301-303 BUCKLAND ROAD- CLAUSE 23 RESPONSE

Further to your recent instructions, we have reviewed the request for further information related to transport matters from Auckland Council and have responded as follows.

Commute Transportation Consultants

Figure 3-1: Weekday Peak Hour Trip Generation - Sat

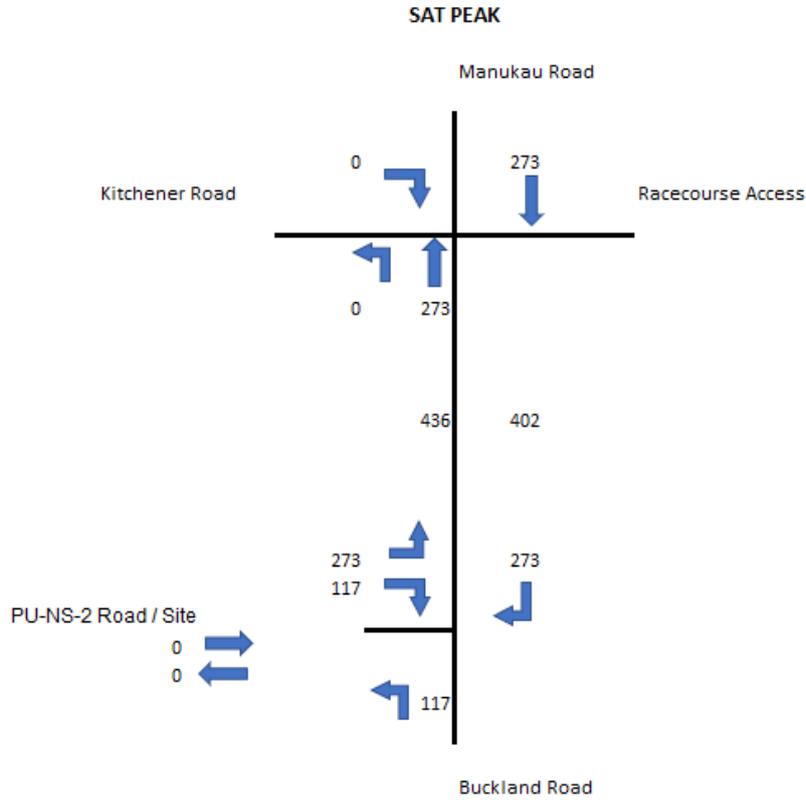
Please provide assessment of the weekend midday peak period.

The weekend Saturday peak has been assessed. Traffic generation is based on the worst case LFR assessment above (780 trips per hour).

The distribution has been based on an entry / exit 50/50 split for weekend midday peak and a distribution to be 70% to north and 30% to the south (as per item T5 below). The increase in traffic is shown in Figure 3-1 below.

Figure 26-1: 400 / 800m catchment

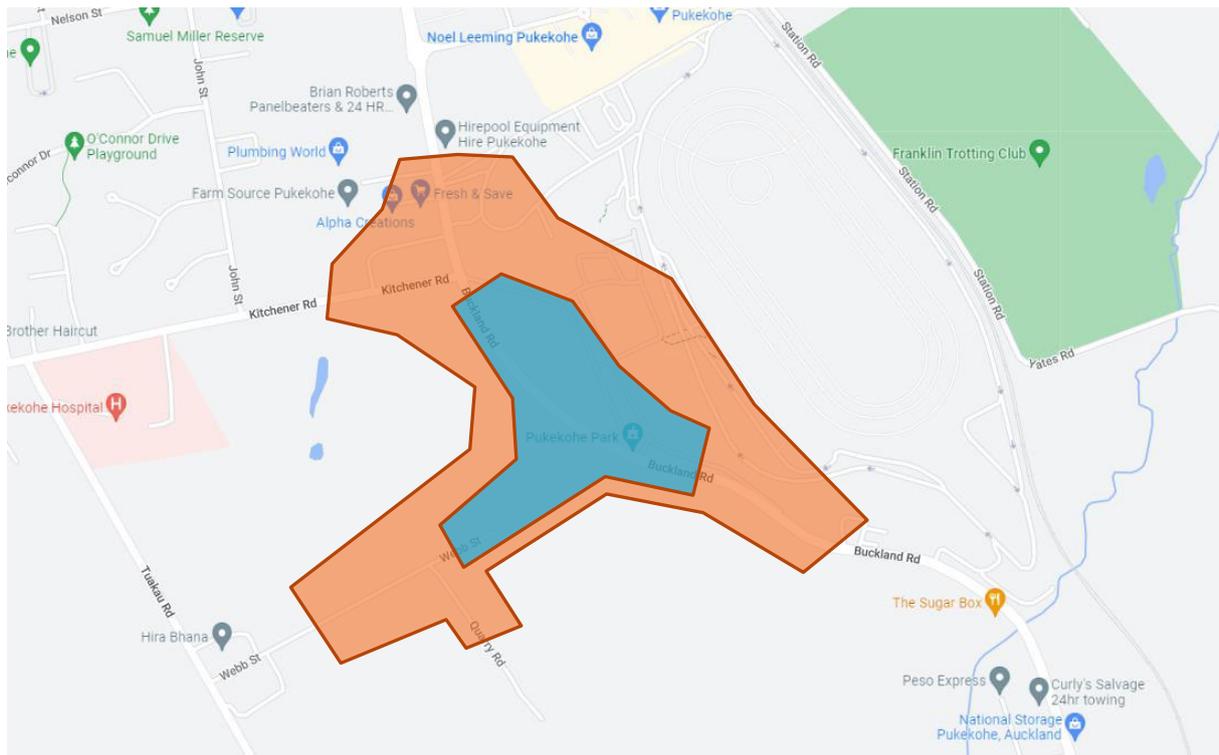
Please provide an assessment of the walkable catchment that includes walking distances of 400m and 800m.

Figure 26-1 shows the 400m and 800m catchment from approximately the centre of the site (assuming existing roads).

It is recognised that the current walking catchment in this regard (400m / 800m) is limited. This will always be the case for Future Urban zoned land which is first to develop in an area. It is however noted that the site is in walking distance to Buckland Road (existing public transport route) and within PC30 site. Even if the PPSP ITA public transport routes are implemented, there will be a connector public transport route on Kitchener Road / Manukau Road which is within 800m of the site.
